KITCHEN (APT. NO. 2)
FLOREA 'D'.

CIVIL LAYOUT

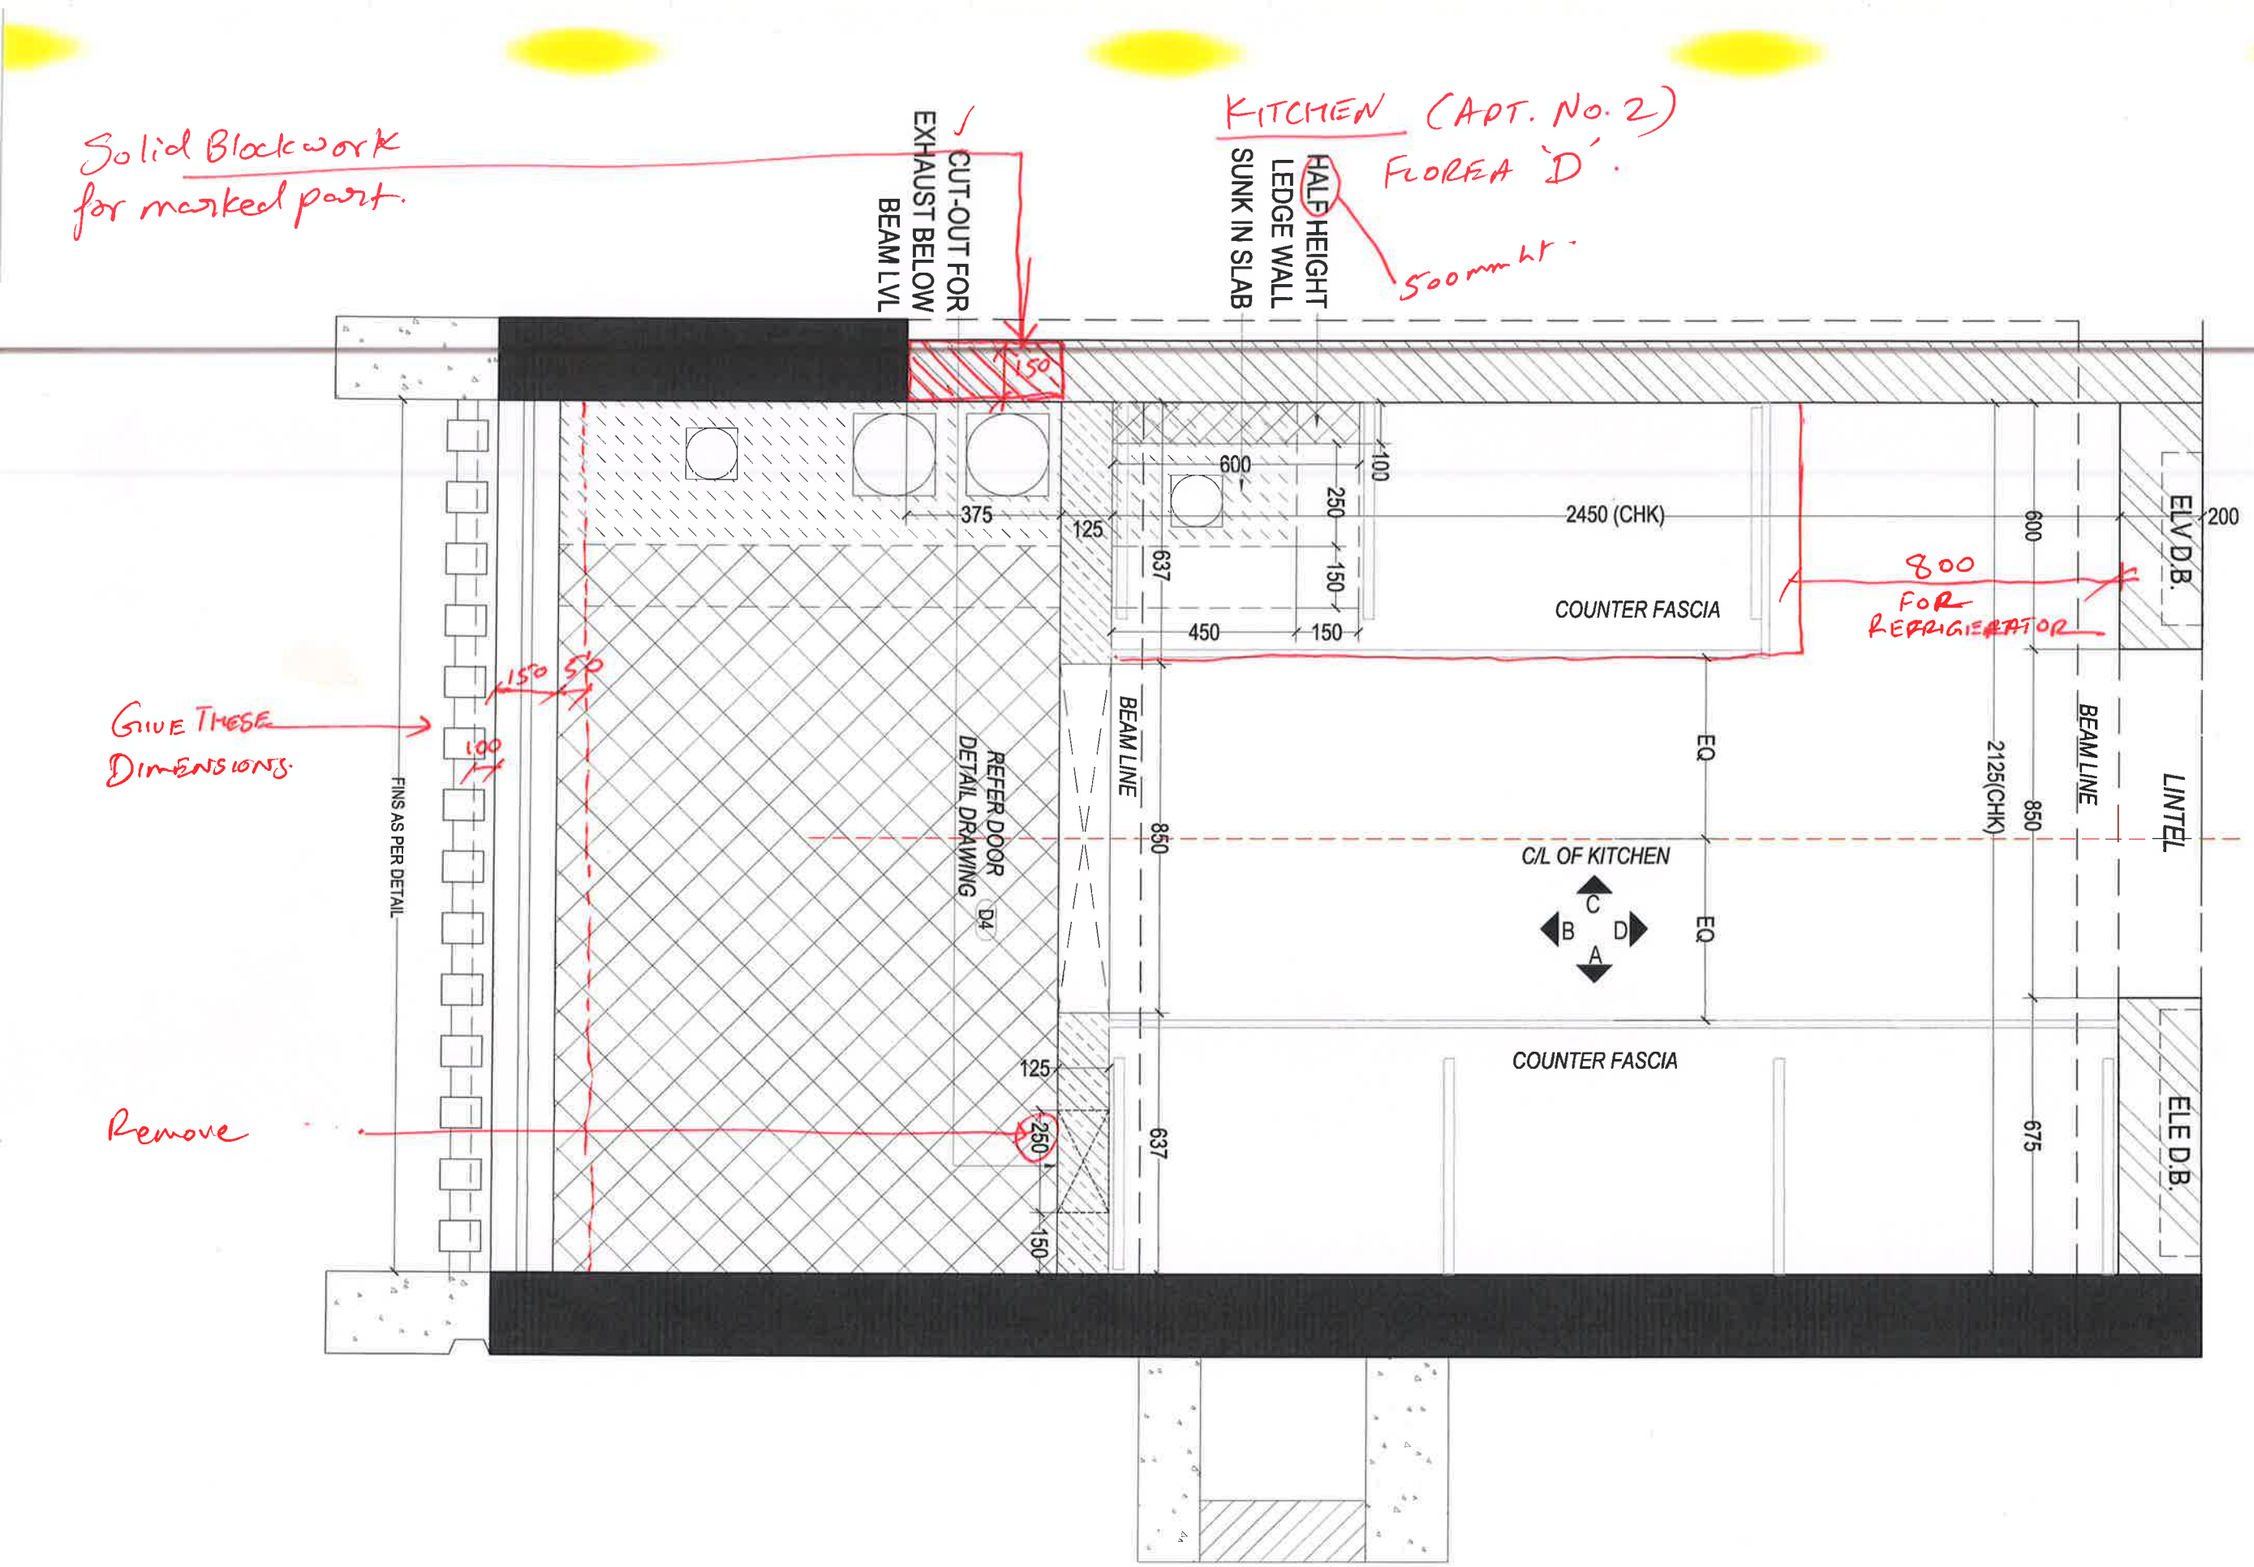
Solid Blackwork for marked part.

THIS BASE PLAN IS FOR APT. NO. 2 (2 BHIC)

NEED TO USE CORRECT PLAN FOR APT. NO. 1

LABEL N.TRAP BELOW PLATFORM. & A&SO GIVE DIM' LOCATION.

LABEL BOTTLE TRAP BELOW SINK. IT WILL BE IN UPVC & WILL BE DIFF. FROM THE ONE USED IN TOILETS.

FIXTURE LAYOUT

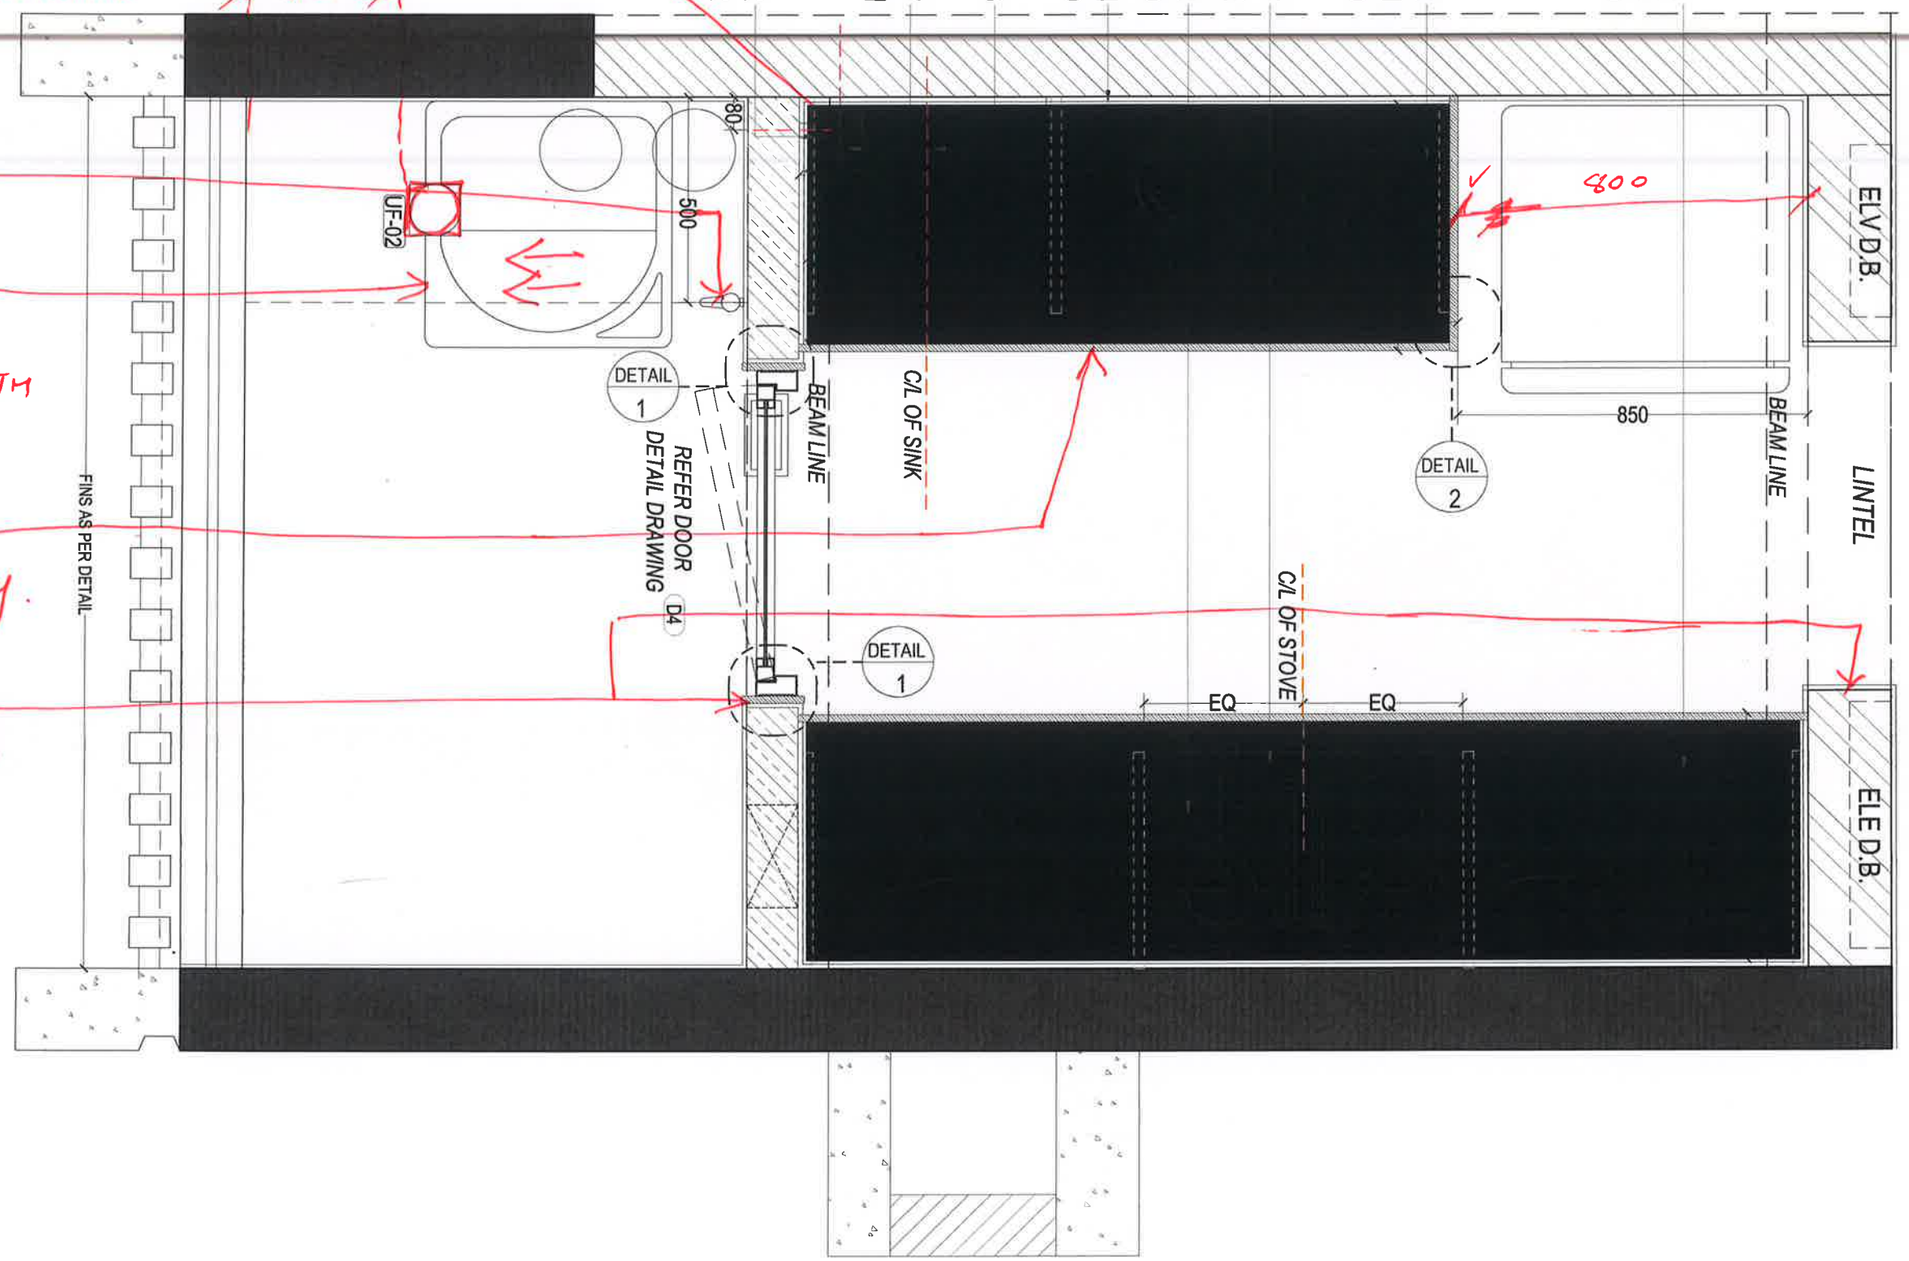
LABEL TAP FIXTURE

SHIFT WASHING MACHINE CLASHING WITH PIPES.

CHECK & MATCH TRANSPERANCY.

REMOVE STONE JAMB. (NOT USED IN CASA)

FLOORING LAYOUT

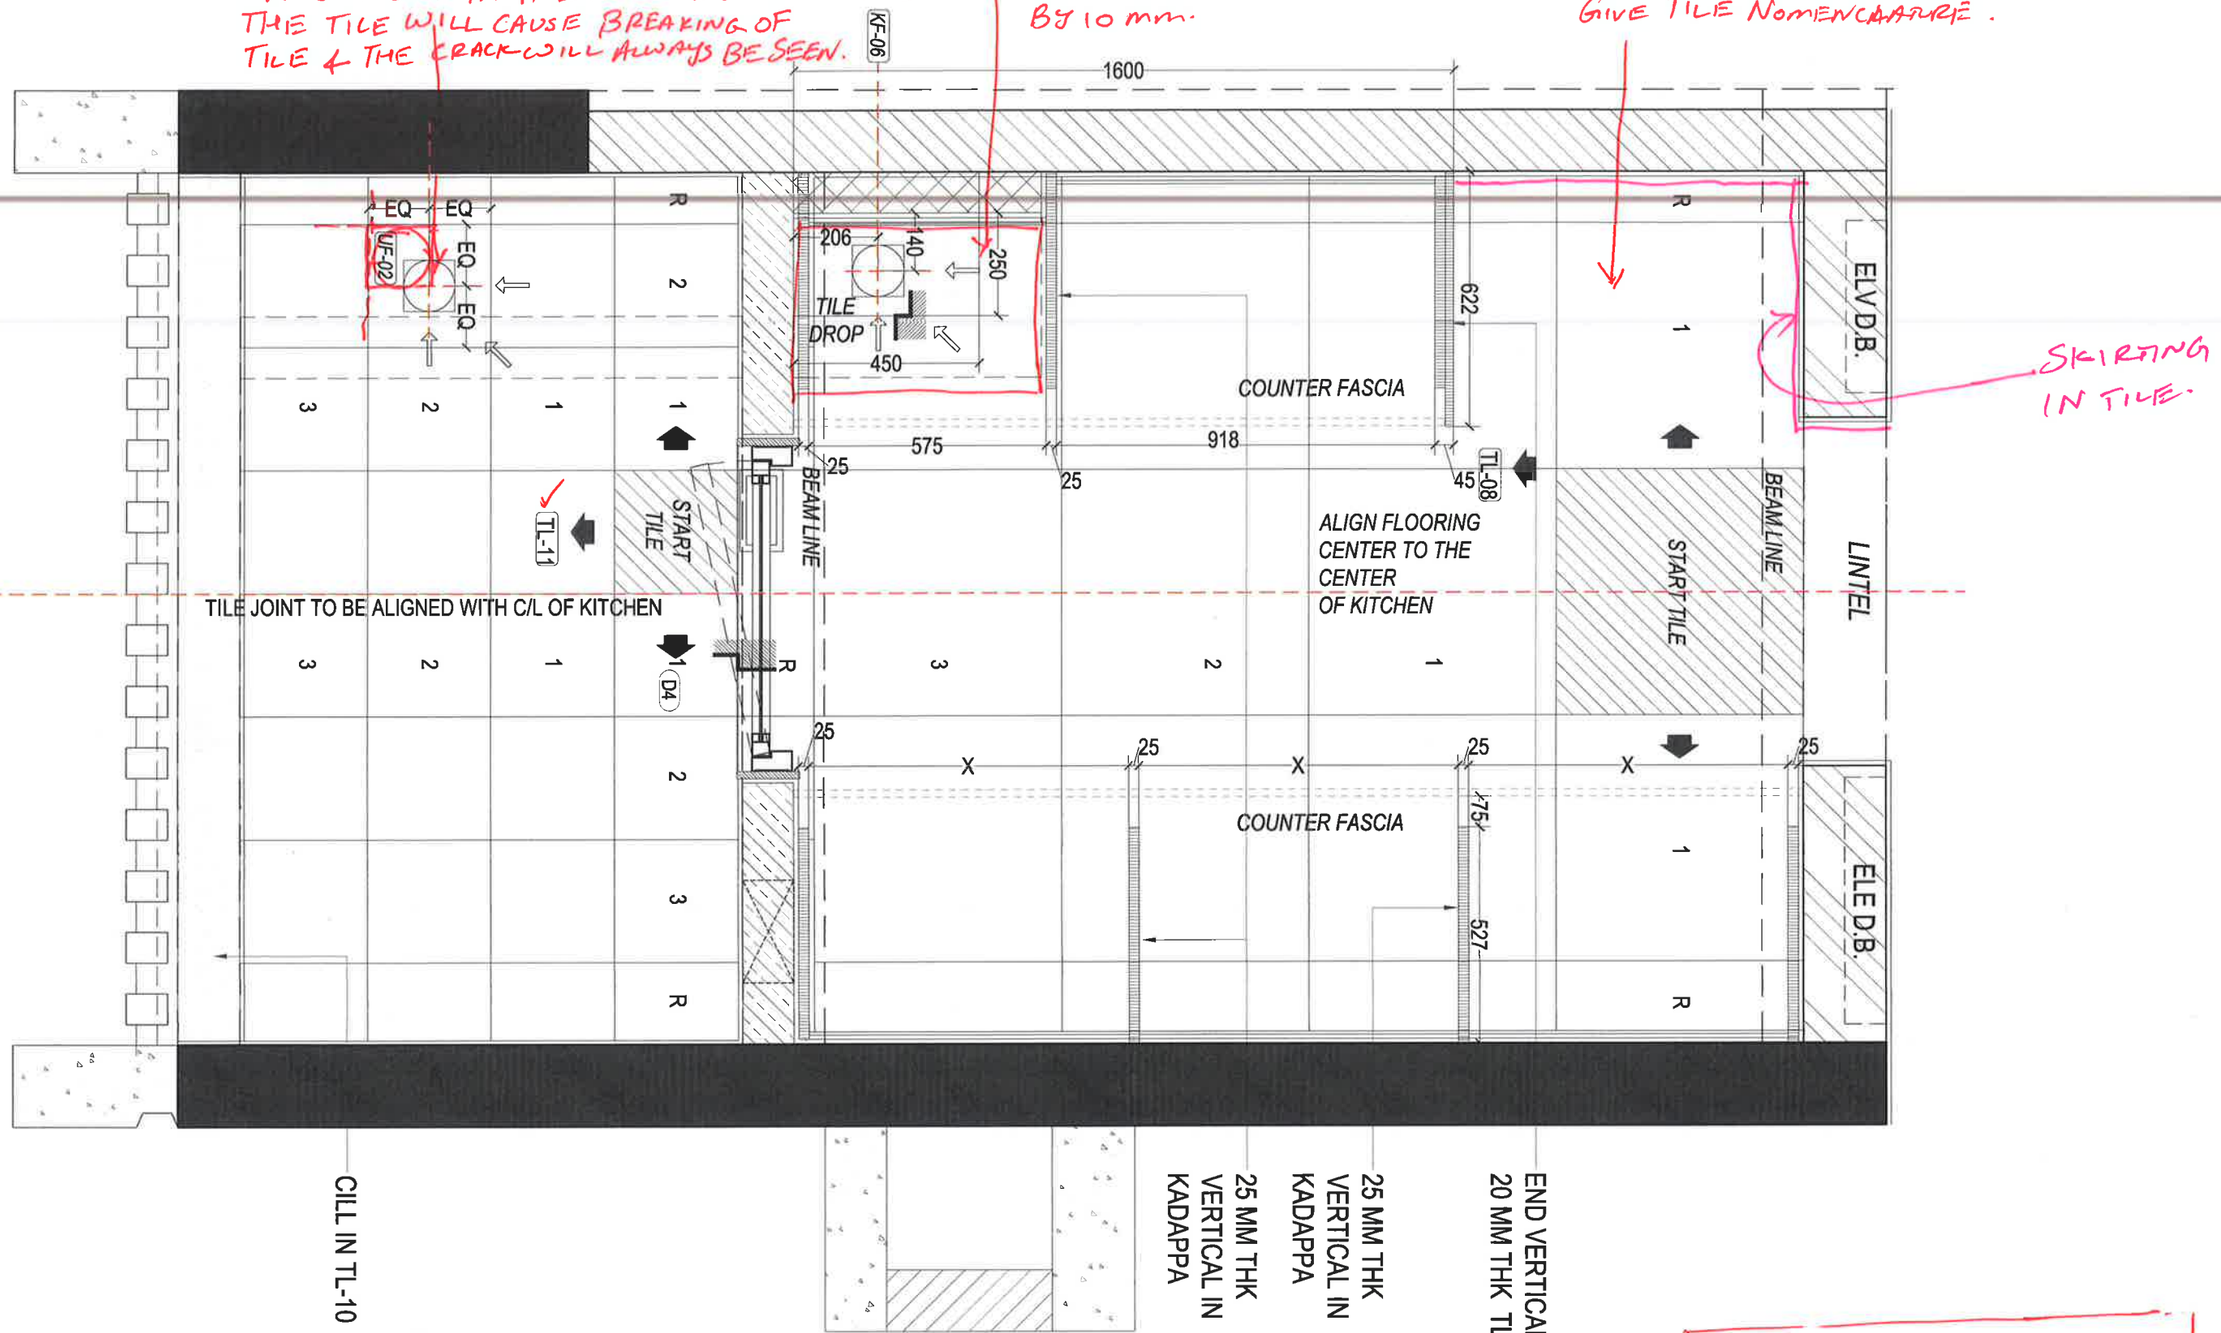
A CUT OUT IN THE CENTRE OF THE TILE WILL CAUSE BREAKING OF TILE & THE CRACK WILL ALWAYS BE SEEN.

AS PER PROPOSED LAYOUT THE COMPLETE REMAINDER TILE TO DROP BY 10 mm.

GIVE TILE NOMENCLATURE.

SKIRTING IN TILE.

R.C.P LAYOUT

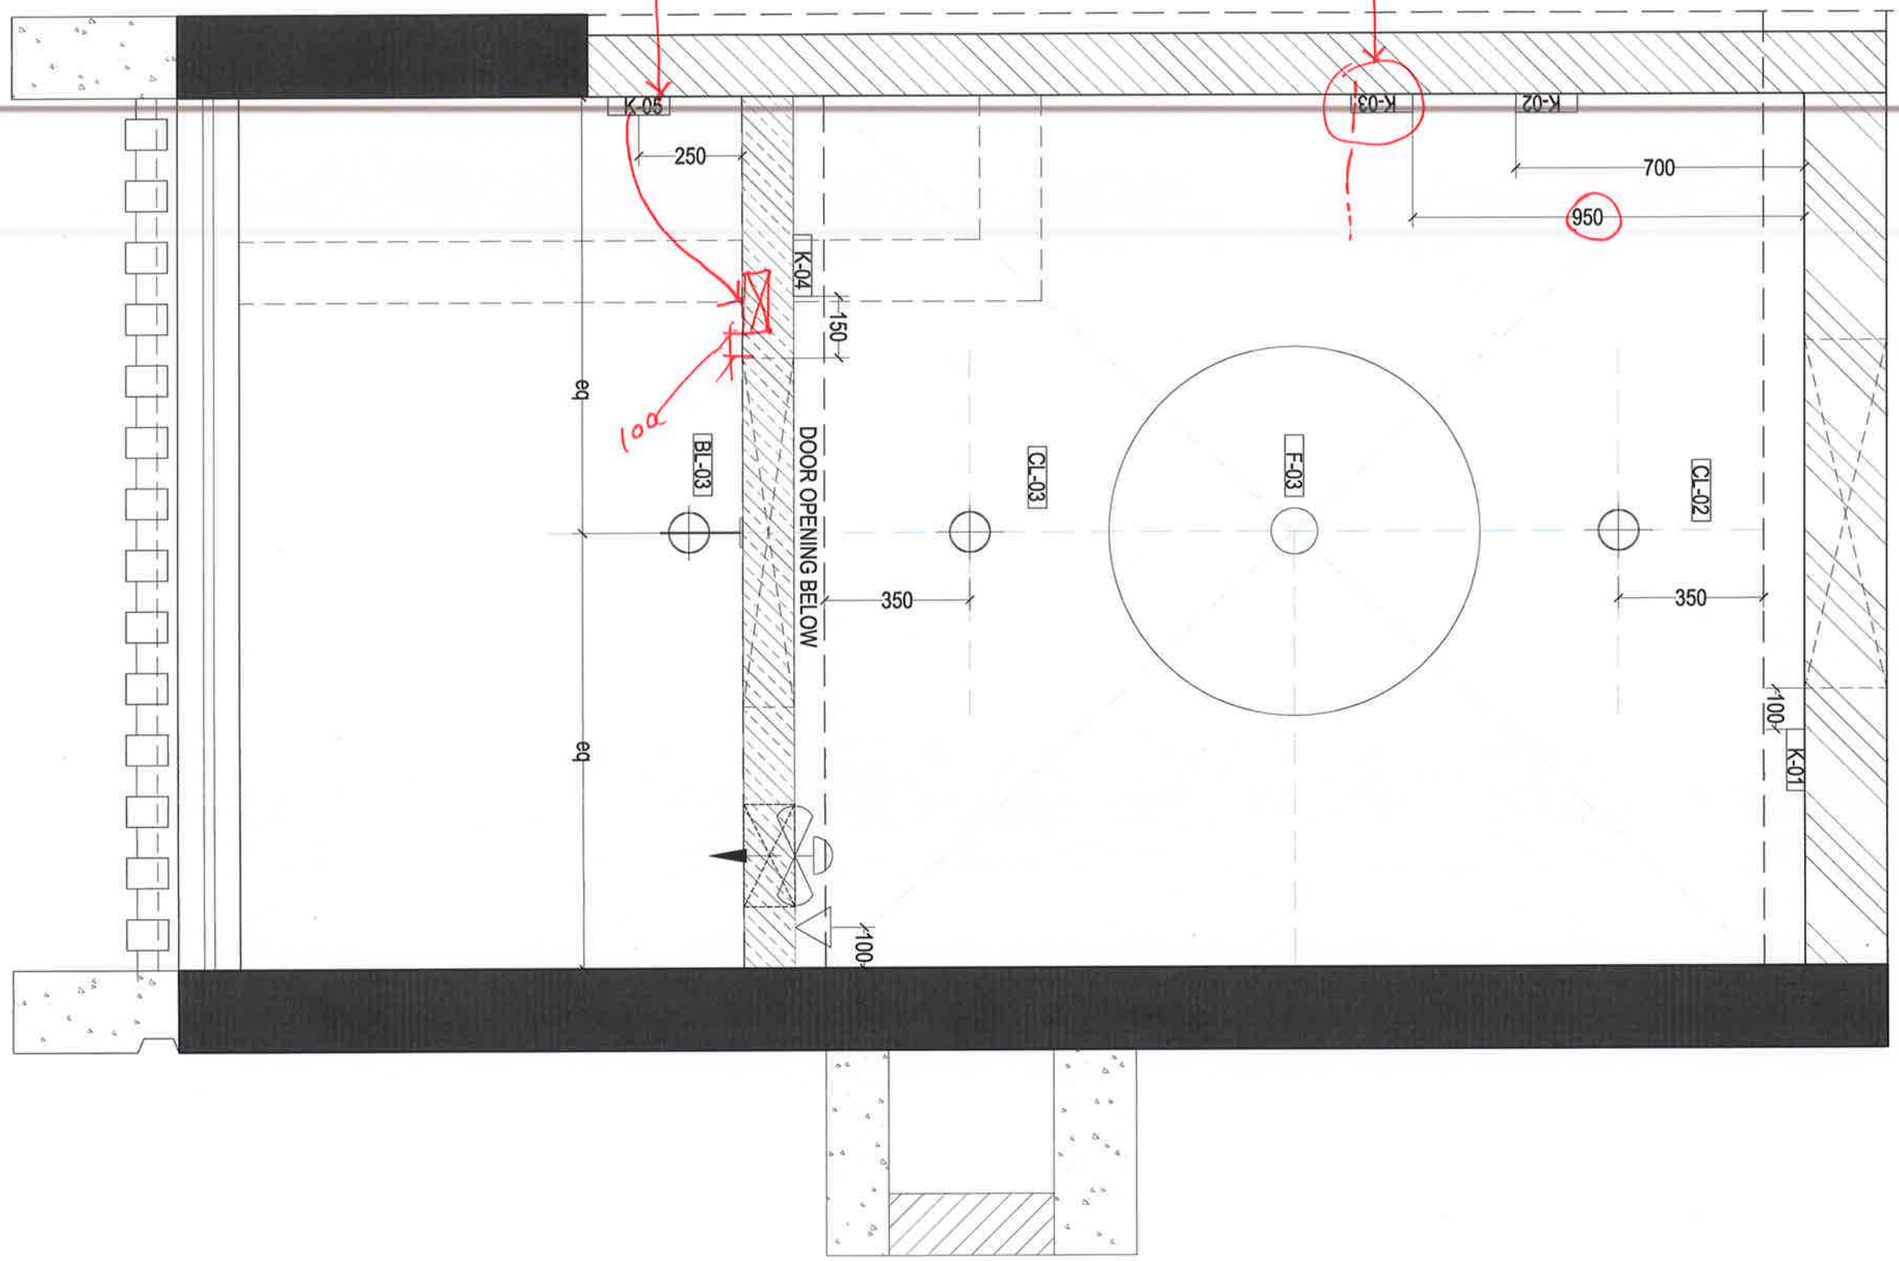
FOR FLOORING LAYOUT (TILES) KINDLY REFER OUR MAIL DATED 17/9/19.

THIS WILL GO BEHIND THE PIPES.

ALIGN WITH TILE JOINT.
